Bittersweet Water Reclamation Facility
 Improvements-Approving Change Order #3
 between Joseph J. Henderson & Son, Inc. and the Village of Bartlett

SUBJECT: Bittersweet Water Reclamation Facility Improvements
- Change Order #3

CHANGE ORDER NO. 3

Drawing 30-ASM1.01 (Sheet 90)

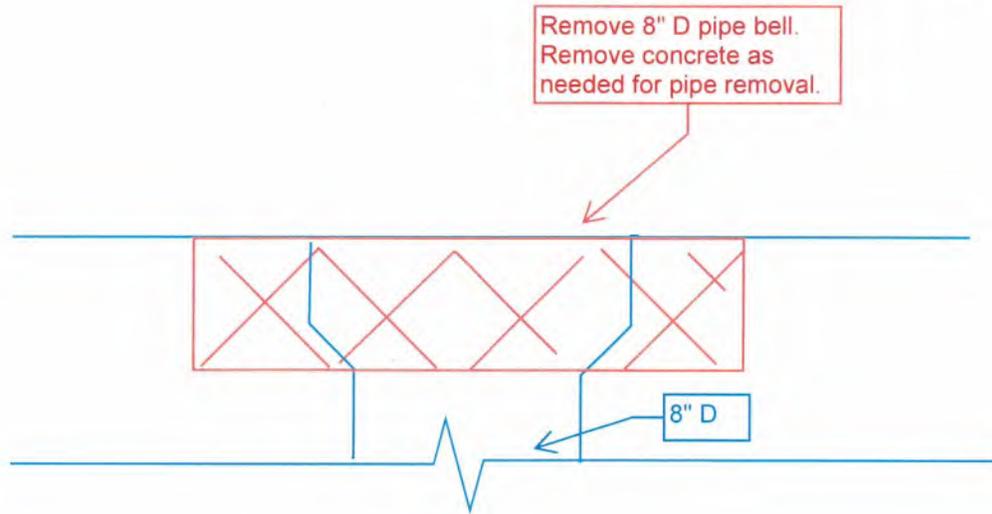
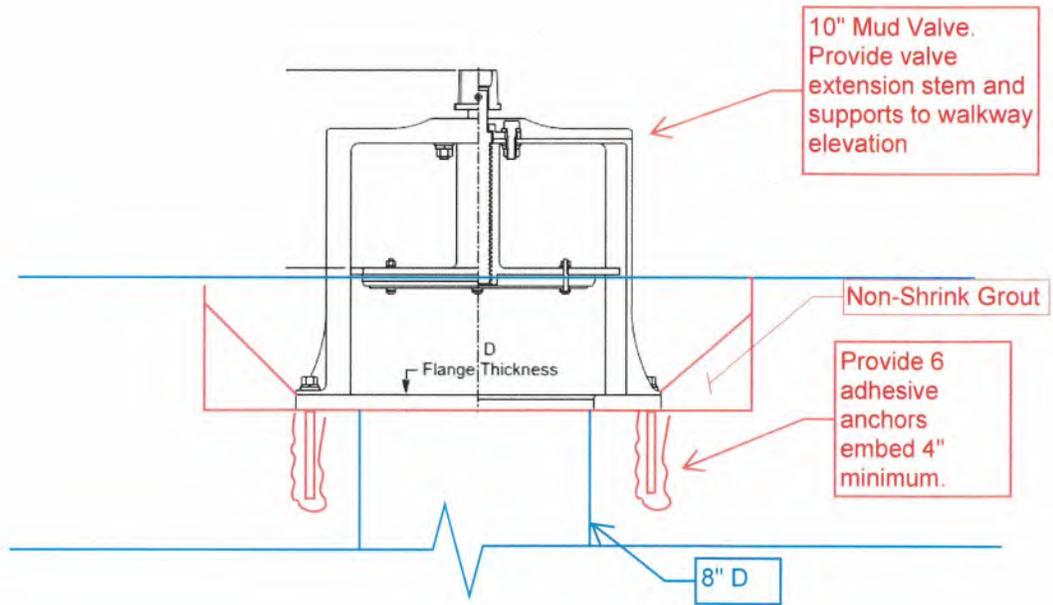
009-01 Change the mud valves in Aeration Zone 1C and Aeration Zone 1B to provide demolition and mud valves as shown on the attached drawing.

SHEET
05-E4.01

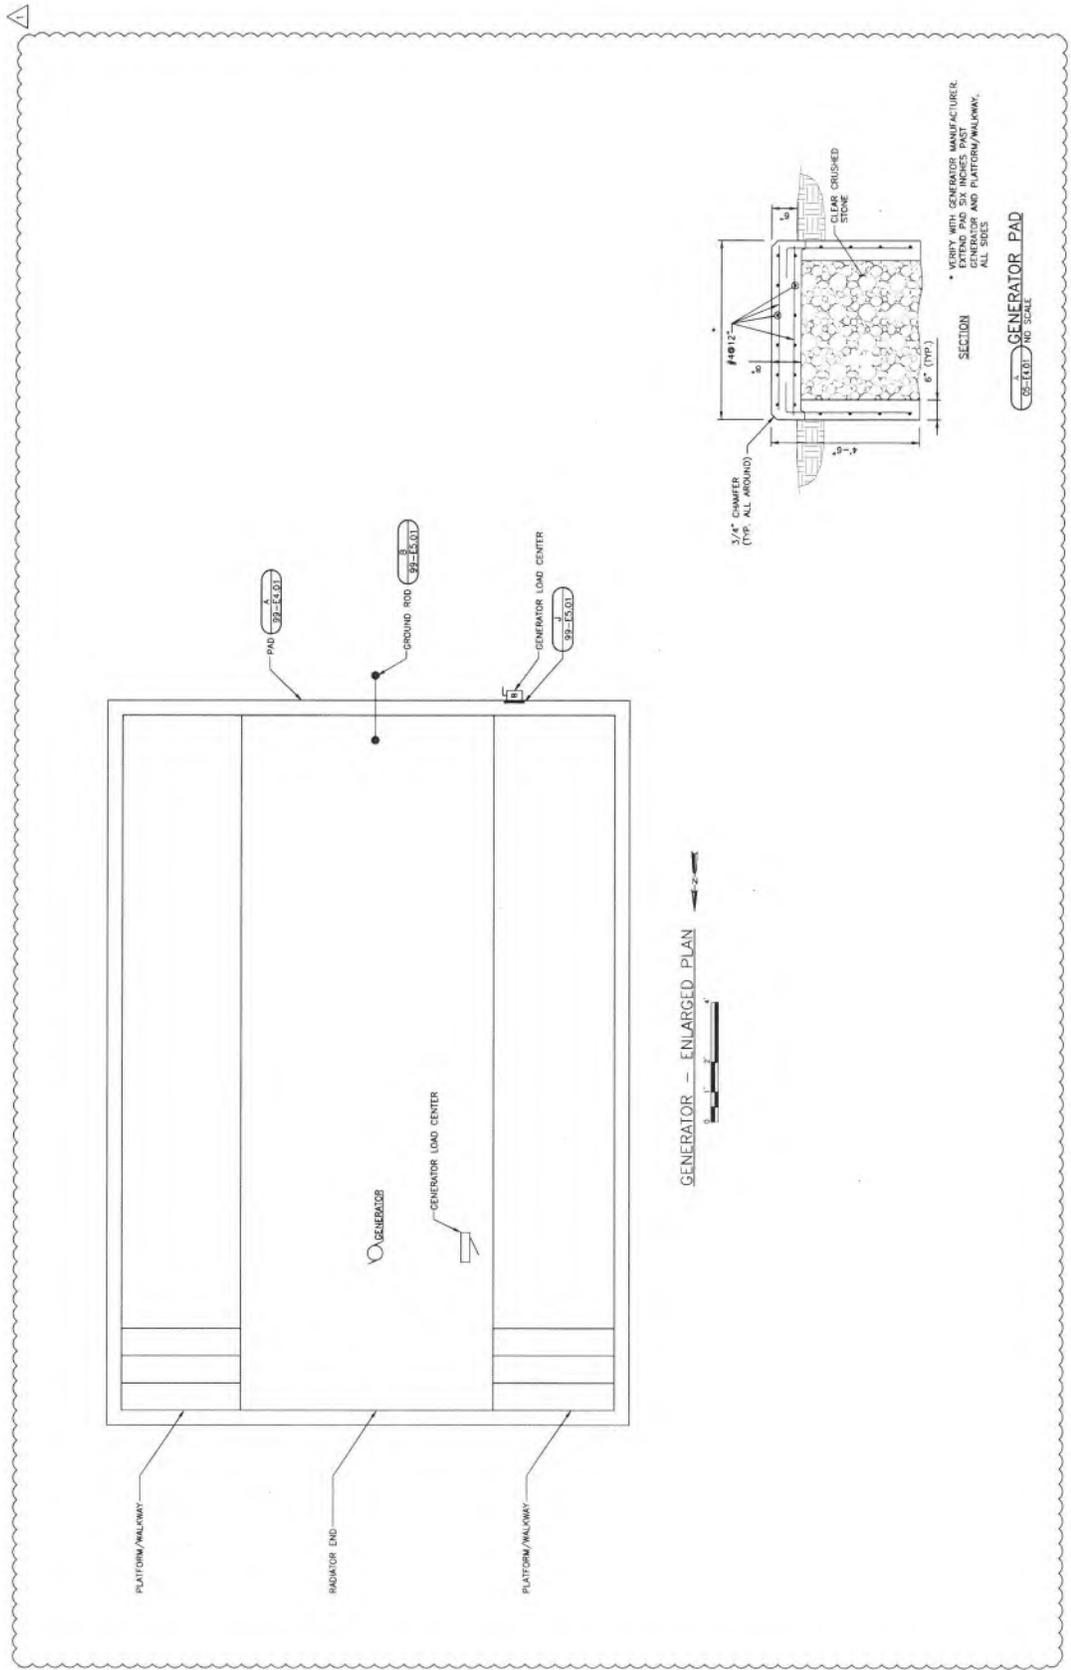
- 011-05 Provide all work associated with the generator installation as shown on the attached updated electrical site plan and enlarged plan (05-E4.01, new plan sheet).

ONE-LINE DIAGRAM
 NO. SCALE

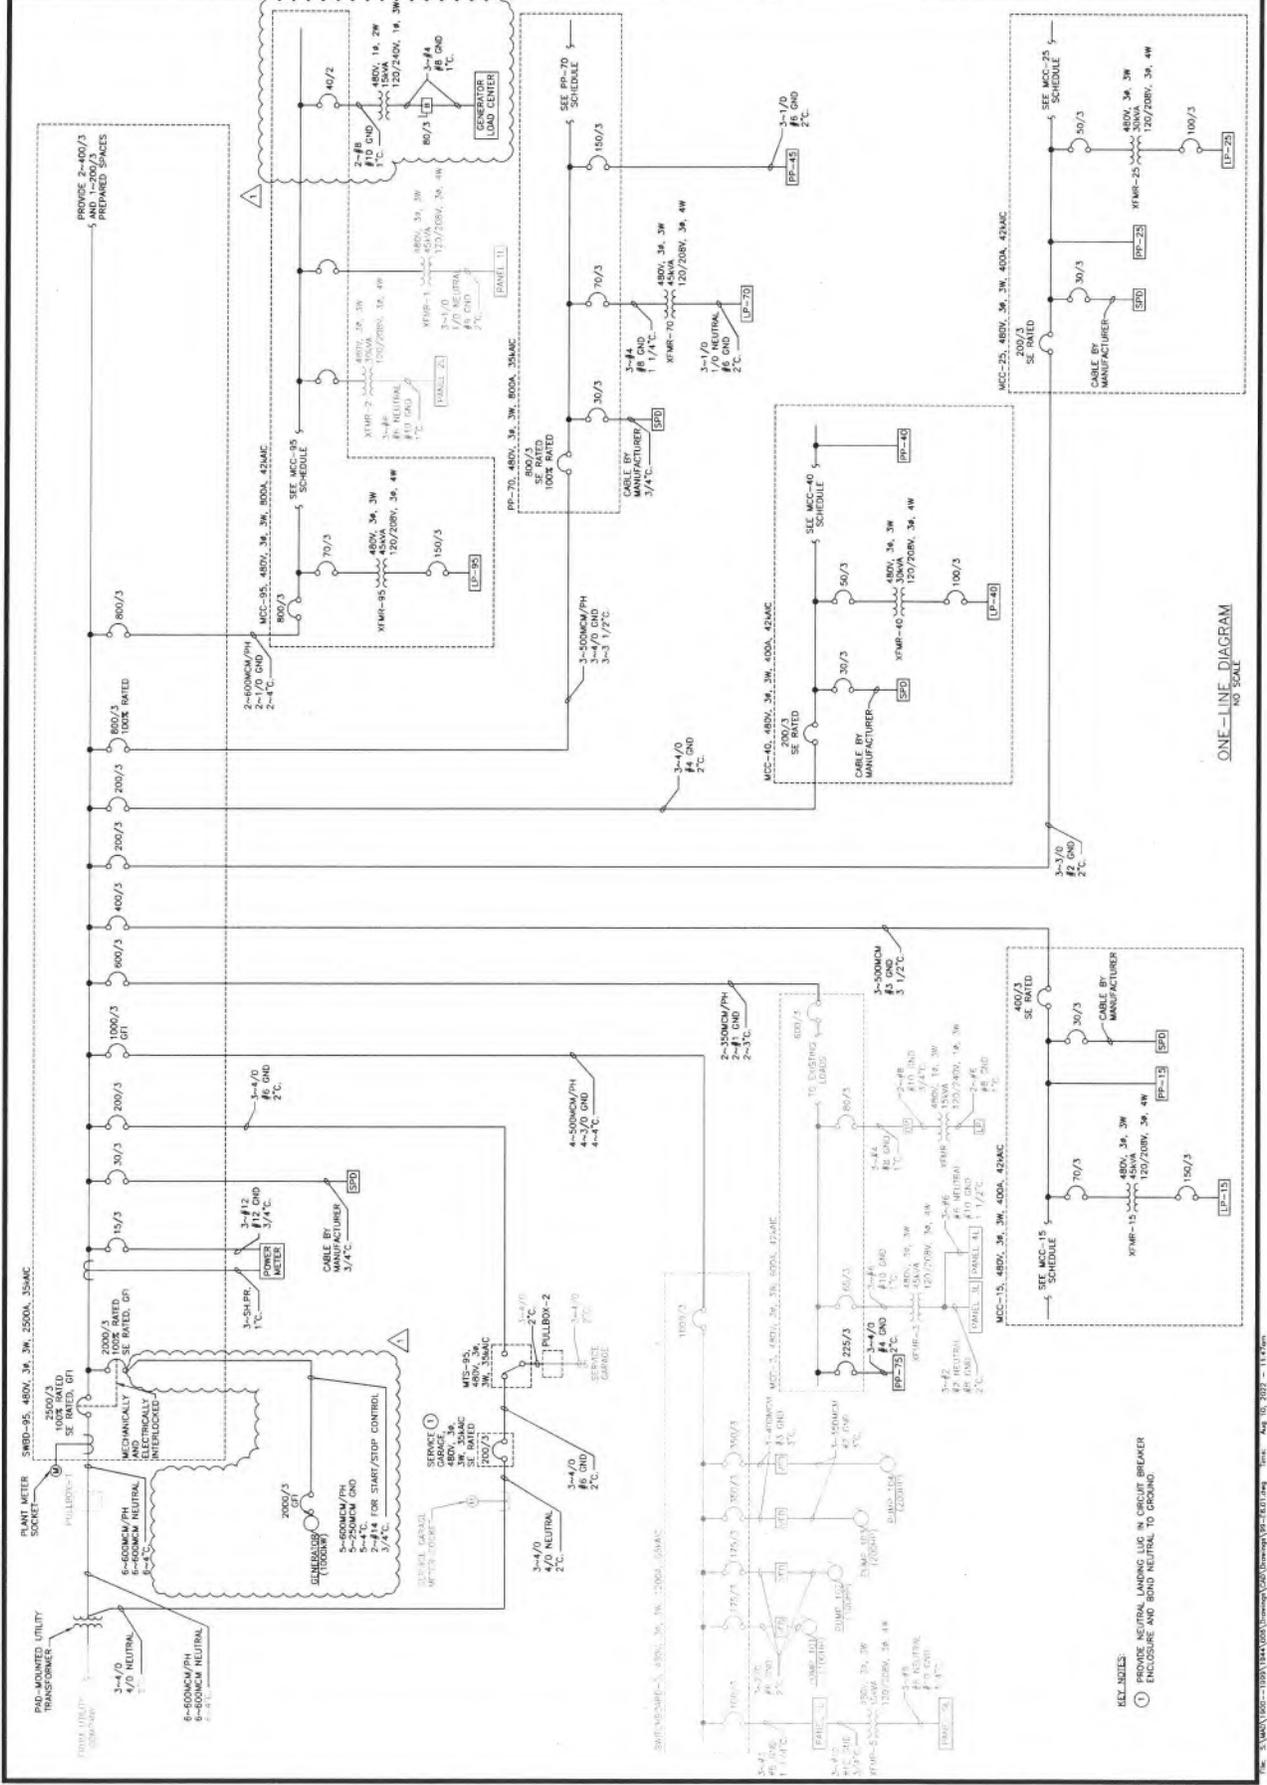
- 011-10 Provide conduit and wiring from the new generator to SWBD-95 as shown on the attached updated one-line diagram. Provide circuit breaker in MCC-95, transformer, circuit breaker disconnect, and associated conduit and wiring as shown on the attached updated one-line diagram. Transformer shall be wall-mounted on the north wall of the Blower Room in Structure 95. Provide a credit for all conduit and wiring from the existing generators to SWBD-95.
